## ANONYMOUS REFEREE #1

5 This is a modeling study to investigate the response of firm to changes in air temperature. The  
investigators run a simple step-forcing experiment to determine the spatial and temporal responses of a  
simulated firm column over Greenland, to step changes of 1 degree C in both warming and cooling. The  
experiment and procedures are well-described and the paper is generally well written. Many interesting  
insights are illustrated in the paper, and it looks to be an interesting contribution to the literature on firm in  
10 a warming world. While the main conclusions may be unsurprising to those who think about firm a great  
deal, the conclusions are well-founded and are well worth publishing. I have mainly a few relatively minor  
issues with the existing study and they should be straightforward to address.

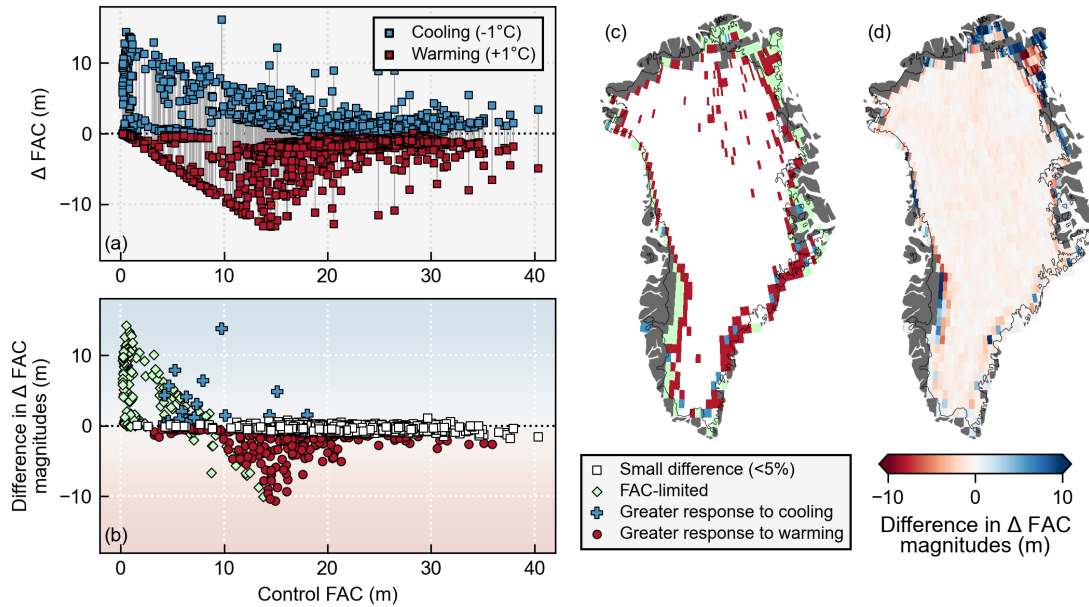
- Appropriateness of title, given Figure 9c: at and near line 250, the authors state that the majority (1282/1724 = 74%) of the grid cells fall into the category labelled "Equal response" in figure 9. This is graphically shown in figure 9c. Given this statement, does the title (claiming unequal response) make sense? I certainly concede the point made in lines 252 and 262 that within this 5% bound the warming is usually greater (pinkish tint in Figure 9d). Figure 2c makes the point (of the title) well but then it's a bit undermined by the later discussion of figure 9c. Maybe instead of "Greenland's firn" in the title you might insert "Greenland's marginal firn"? Or change some of your binning here in this paragraph to make the point in the title more clearly made? Perhaps this is pedantic but seemed worth discussing.

As it is, the title conveys our most important result: both in the Greenland Ice Sheet interior and closer to the margins, the response to warming is greater. More importantly, we're communicating that when integrated across the full ice sheet, the warming response is greater. With that in mind, we have chosen to keep the title the same.

However, we appreciate the reviewer's point here about the title and the use of "equal response" within the paper. Even in the cases we originally labeled as "equal", the response to warming is slightly greater, but only by a small amount. To avoid using the word "equal" when the response magnitudes are not actually equal, we have instead changed how we describe these "small difference" relationships. We have changed the classification in the original Figure 9 (Figure 8 in the updated manuscript) to call this category "small difference (<5 %)" responses. We have also made changes to the text in Section 3.3 that describes this figure. Below are our modifications for sentences in lines 249 and 260, respectively.

***In a small difference response relationship, the difference in magnitudes of firn air content change due to cooling and warming is <5 %. Most grid cells fall into this category with 1282 of the 1724 grid cells having a similar gain of firn air content due to cooling as the loss due to warming (Fig. 8c). It is worth noting that even in these cases where the responses to warming and cooling differ by a small amount, the response to warming is slightly but persistently greater in magnitude (Fig. 8b, d).***

***For the most part, the typically dry ice sheet interior has a response relationship with small differences (<5 %) between warming and cooling. Although these locations are defined by a similar-magnitude response, the vast majority of these grid cells have a slightly greater response to warming than to cooling when comparing absolute magnitudes of the responses (Fig. 8d).***

The updated figure (originally Figure 9 but relabeled as Figure 8 in the revised manuscript) is shown below.

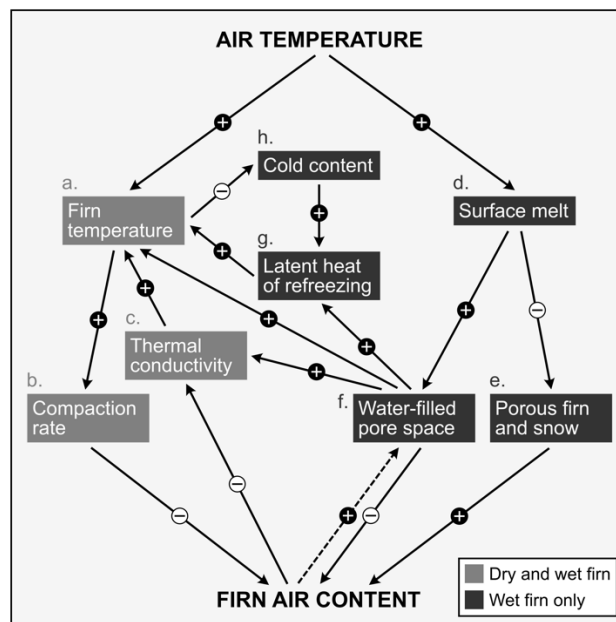
- Figure 10: This is a pretty complicated figure, which may be the point, but it's challenging to follow the description in the text along with the figure. One option would be to have letters or numerals on each box, so that instead of referencing 'Figure 10' in the text, you can refer to a specific box or set of boxes in the figure.

We agree that this is a complex figure, and we have made the suggested changes so it is more easily understood. There are now letters labeling each box on the figure, and we have added references to the specific boxes throughout the text in Section 4.1. The modified figure is shown below.
